U. S. NUCLEAR REGULATORY COMMISSION
REGION I

Report No. 50-244/90-24

Facility Name: R. E. Ginna Nuclear Power Plant

Inspection Summary: Announced Safety Issues Inspection of the licensee's implementation of NRC Bulletin 88-04

RHR System Pre- and Post-Modification Configuration

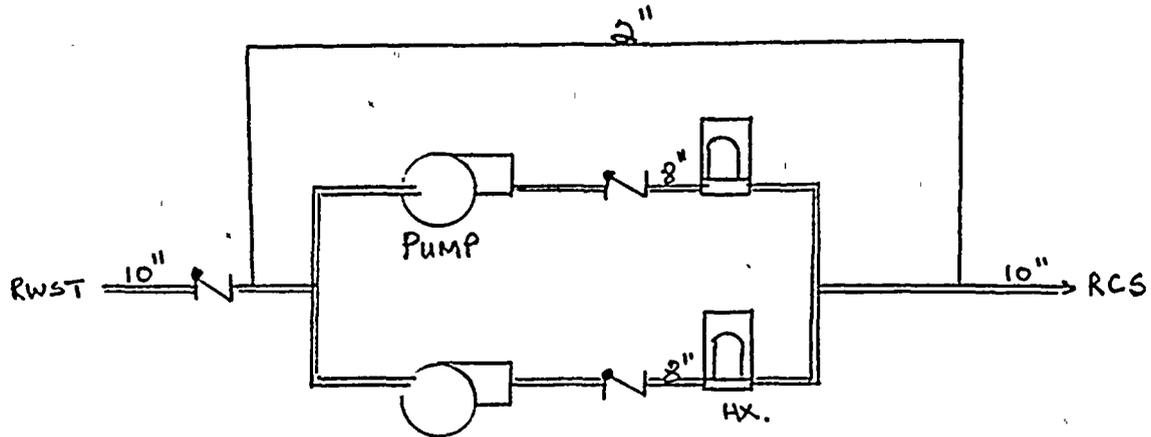
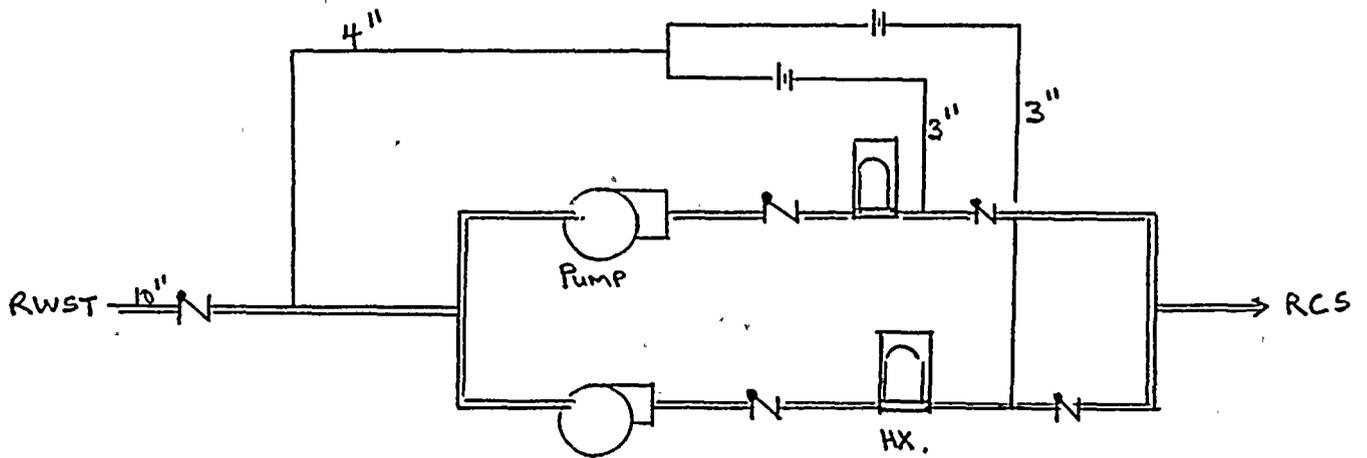
Ginna's RHR system consists of two 100% capacity pumps each rated for 1560 gpm at 280 feet total head and 1770 rpm. The pumps discharge into parallel paths each with a check valve, heat exchanger, and control valve into 8-inch piping. The discharge lines merge into a common 10-inch line which discharges into the "B" reactor coolant system cold leg. See Attachment A for the minimum flow configurations before and after modifications.

The previous configuration using a 2-inch flow line provided either 200 gpm minimum recirculation flow for single pump operation or 100 gpm each when both pumps were running. The licensee found this configuration susceptible to pump dead heading and inadequate for minimum recirculation flow. Modification package No. 4675 was implemented to provide a 3-inch minimum flow line for each pump.

RG&E's initial review of periodic test data showed that there was a 2 psi difference between the two RHR pumps' developed pressure at the 200 gpm. A special test (PT-2.2 Rev. 39, RHR System) was performed on December 16, 1987 and again on December 22, 1987 to more accurately determine and establish operational limits during parallel operation. The results showed that when both pumps were operating in parallel, the "B" pump delivered 200 gpm and the "A" pump delivered only about 5 gpm flow. During the tests,

The long term corrective action was implemented by modification package No. 4675 during the 1989 outage when the minimum flow recirculation system was redesigned. An independent 200 gpm recirculation line was installed for each pump. A sketch of the configuration is shown on Attachment A.

Test procedure No. SM-4675.4, Rev. 0, RHR Recirculation system functional test (1989 Phase), was written and approved on April 29, 1989 to control the testing of the RHR modification. In May 1989, this test was completed. Test results demonstrated that (1) each RHR minimum flow recirculation line provides a minimum flow of at least 200 gpm; (2) there was at least 200 gpm recirculation flow for each pump when both pumps were in the recirculation mode; and (3) there was no pump dead heading. Test No. SM-4675.9 Rev. 0, RHR system shutdown cooling full flow test, performed in May 1989 demonstrated that the modifications did not degrade the RHR system flow. Test report "SM-4675.4, SM-4675.9," EWR 4675, Rev. 0 was generated to document the licensee's review of these tests.

The inspectors reviewed the results of post-modification tests SM-4675.4 and SM-4675.9 and had no further questions in this regard. The inspectors performed a walkdown of the installed modification to the RHR system and verified that the modification was installed as designed. No unsafe conditions were identified. The inspectors verified that the minimum

The inspectors concluded that the licensee has adequately responded to the concerns raised by NRC Bulletin 88-04. The licensee has adequately modified the RHR system and successfully demonstrated that the new recirculation lines preclude dead heading in the minimum flow recirculation mode with one or both pumps running. The recirculation lines are sized to provide adequate flows for the pumps. The established minimum flows are consistent with those recommended by the pump vendors.

SI System Pre- and Post-Modification Configuration

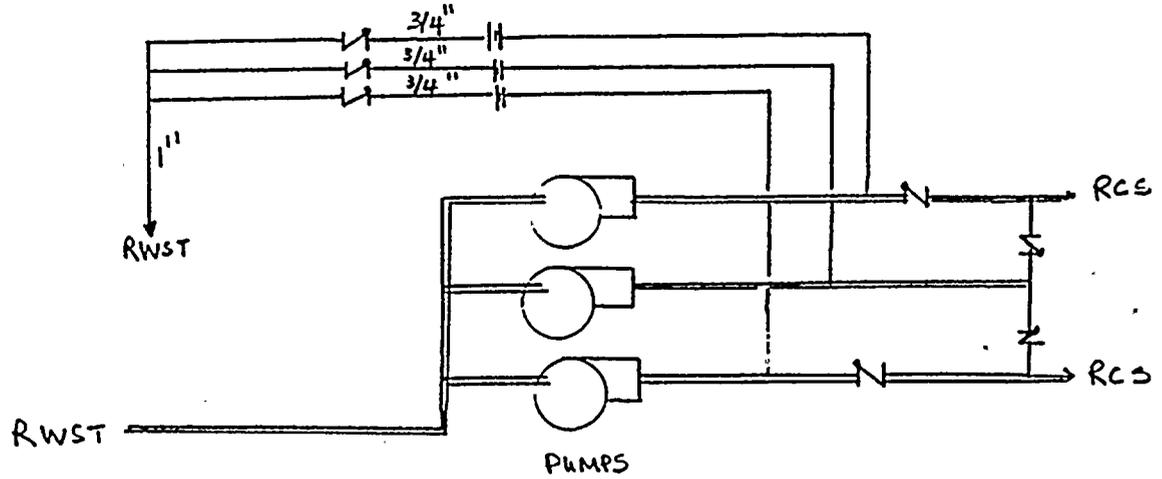
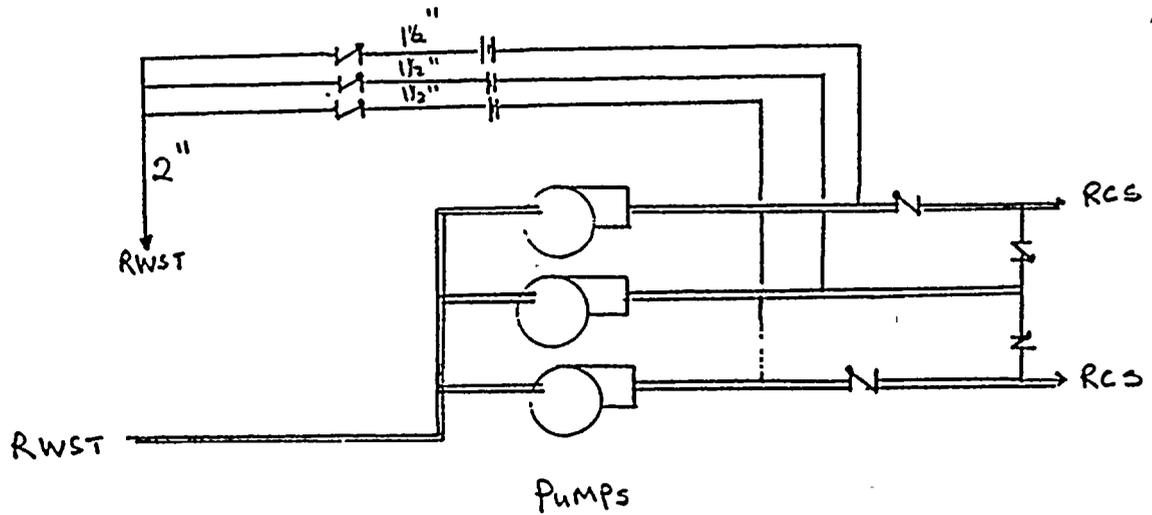
recirculation line which discharge into a common 1 inch line. The common, 1 inch line discharges to the Refueling Water Storage Tank (RWST). A sketch of the configuration is shown on Attachment B.

In 1988, the licensee performed a special test to determine the adequacy of the 30 gpm minimum flow for each pump. With a 3/4 inch common test line, the pumps were operated separately at 30, 53 and 100 gpm. No appreciable difference in the pump's vibration levels was observed. All vibrations were within an acceptable range and test results were included in the licensee's July 7, 1988 letter to the NRC. In spite of the above, the licensee modified the pumps' recirculation systems to provide increased recirculation flow. The basis for this modification was to reduce the potential for accelerated wear of the pump internals due to low flow operation.

Modification package No. 3881 was implemented in 1989 to provide a 1½-inch recirculation line for each pump in place of the former 3/4 inch lines. These individual recirculation lines discharge into a two inch common line connected to the RWST. This modification is different from the licensee's proposed action for NRC Bulletin 88-04. Specifically, the licensee's letter, dated July 7, 1988, stated that the system will be modified to provide 1" individual pump recirculation lines and a 2" common line. At the exit meeting, the licensee acknowledge the discrepancy and agreed to update their response to reflect the as-installed configuration of the system.

The post-modification tests determined that each recirculation line performed as designed. Procedure No. SM-3881.4 Rev. 0, documents the test results. The tests also demonstrated that all three pumps can be in the minimum flow recirculation mode at the same time without the potential for deadheading in any of the pumps. The test verified that the new recirculation lines did not compromise the system flow to the RCS. Test Report No. SM-3881.4, 3881.5 was generated to document the results of the post-modification tests. A 10 CFR 50.59 safety analysis was performed by the licensee and is documented in a report titled "Safety Analysis, Ginna Station, SI Pump Recirculation."

The inspectors reviewed the licensee's Design Criteria, the Independent Design Review for the modification and the post-modification tests to the recirculation system. The inspectors found these documents to be complete and accurate and that the licensee had established the minimum flow rates consistent with the pump vendor recommendations. The vendor's recommendations were based on expected differential temperature increases. The vendor indicated that the original 30 gpm recirculation line was adequate to protect the pump against unexpected operation at the shutoff head for very short periods of time. The vendor further suggested that a recirculation flow of 150 gpm for continuous operation (24 hours/day) was acceptable. The inspectors reviewed the results of tests performed at the 100 gpm recirculation flow and found them to meet the acceptance criteria. The ASME Section XI periodic tests for these pumps are routinely performed at 150 gpm.

The licensee has adequately responded to the issues discussed in NRC Bulletin 88-04 for the safety injection system. While the SI system was found not susceptible to the concerns raised, the licensee modified the minimum flow recirculation system to increase flow from 30 gpm to 100 gpm per pump. Post-modification tests demonstrated the following:

Main Auxiliary Feedwater Miniflow Recirculation Configuration

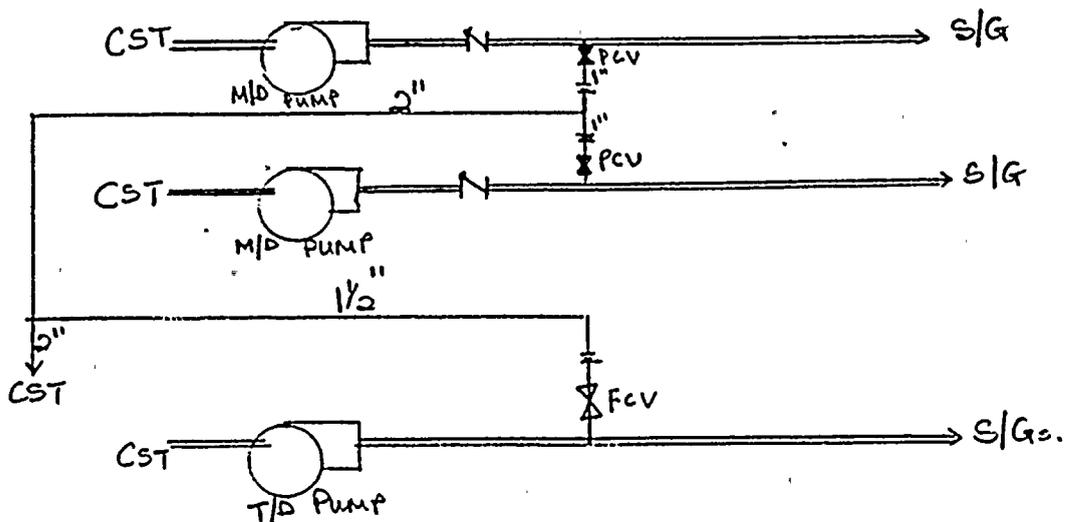
Each pump has a 1 inch minimum flow line which taps off the pump's discharge piping and has a pressure breakdown orifice before tying in with the other pump's minimum flow line. A sketch of the configuration is shown on Attachment C.

The motor driven pump's minimum flow line orifices are sized for a flow of 40 gpm while that of the turbine driven is sized for 90 gpm. Each of the minimum flow lines has a control valve to regulate the flow through the line relative to the flow in the pumps discharge line. This essentially ensures adequate flow through the pump. The control valve on each of the motor driven pump's minimum flow line is normally closed and opens automatically, as required, based on the pump's discharge pressure. The

The inspectors reviewed system drawings and performed a walkdown of the minimum flow recirculation system. They observed a discrepancy between as-built configuration and P&ID 33013-1237 Rev. 19. The P&ID did not show that orifices were present on the motor driven pump's recirculation lines. This discrepancy was discussed with the licensee. The issue of drawing discrepancies was addressed in NRC inspection report no. 50-244/87-27 and the licensee had initiated a project to upgrade all P&IDs. The inspectors concluded that the discrepancy identified in P&ID 33013-1237 Rev. 19 was being tracked under this drawing update project for completion. Isometric drawing 4155-B-305-015-III shows the as-built configuration of the orifices. The inspectors identified no other concerns during the system walkdown.

The licensee has adequately evaluated the AFW main system for the concerns addressed in NRC Bulletin 88-04. The inspectors concluded that the pumps were adequately protected against the concerns of the bulletin.

Standby Auxiliary Feedwater Miniflow Recirculation Configuration

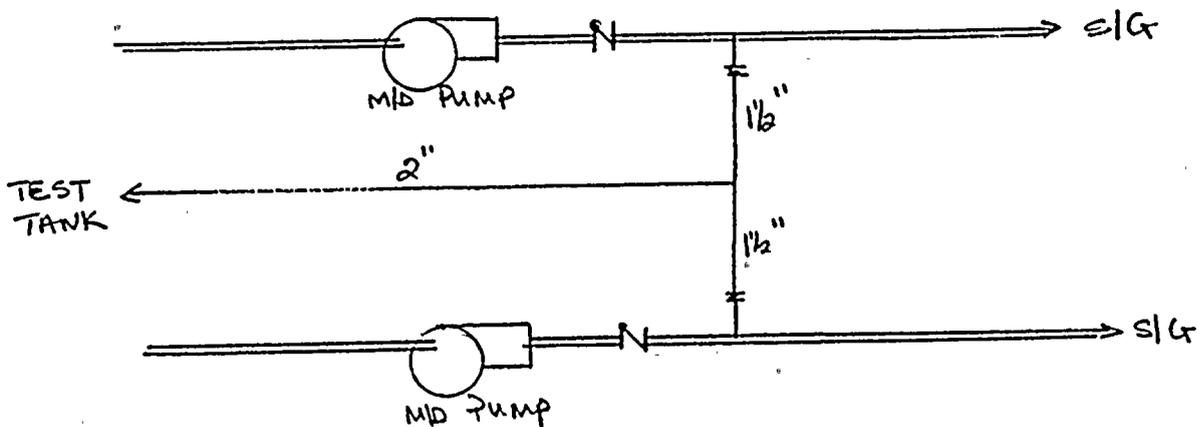
The Standby Auxiliary Feedwater System (SAFW) has two motor driven pumps each rated at 200 gpm at 1085 psig. Each pump has a 1½ inch recirculation line with an automatic flow controlled air operated valve and a pressure breakdown orifice. The air operated valve is normally closed and fails to the open position. The valve is designed to open when the discharge flow decreases to 80 gpm. Each pump feeds a separate steam generator. The configuration of the recirculation lines is shown on Attachment C. The SAFW pumps are manually actuated and controlled and serve as a backup for the Main Auxiliary Feedwater pumps.

The inspectors performed a walkdown of the minimum flow recirculation configuration and ascertained that it is as described in the drawings. The inspectors also reviewed the system's operating procedure No. ER-AFW.1 Rev. 8 which provides instructions on how and when to use the SAFW pumps. The procedure adequately ensures that the pumps are not operated at shut off head. The pumps are tested monthly per ASME Section XI requirements during which the recirculation valves are verified fully open at a system flow of 50 gpm.

A 48-hour endurance test performed on the pumps demonstrated the adequacy of the 50 gpm minimum recirculation for each pump. The results of this test were reported to the NRC in RG&E's letter, dated May 28, 1980. The pressure breakdown orifices in the recirculation lines upstream of the tie-in prevent pump deadheading when both pumps are in recirculation mode. This joint operation in the recirculation mode will however have to be deliberate and manual since the systems operation (manual) and operating procedure preclude this from happening.

The inspectors found the licensee's evaluation of the SAFW pumps' recirculation system with regards to Bulletin 88-04 adequate. The inspectors concluded that the pumps' operation and operating procedure preclude simultaneous minimum flow recirculation except when done intentionally. The pumps have adequate recirculation lines and they are not susceptible to the concerns raised in the Bulletin.
